Access Compliance Report Public Rights-of-Way (Pedestrian Signals)

Main Street: **ORANGEWOOD_AVE** Cross Street: **LOS_ALAMITOS_BLV** Location: **NW**

ADA ID: **SGRK211217121013** Signal Type: **One Push Button-Non APS** Overall Compliance: **No** Severity Scores: **BTN 1: 35** **BTN 2: N/A** **No BTN: N/A**

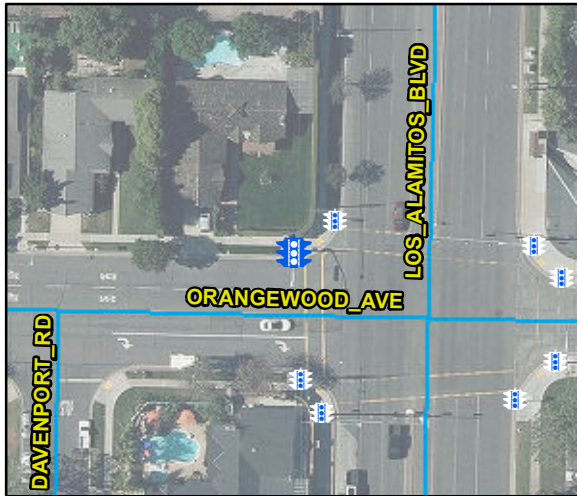
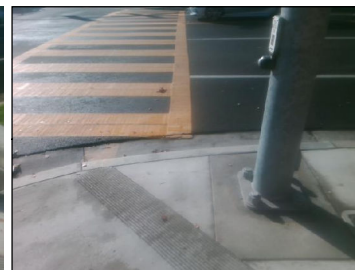
OC Std/PROW: **R404.2, R404.3, MUTCD 4e.08**

Possible Solutions: Replace Signal Push Button With APS Button. Remove and Replace Clear Space.
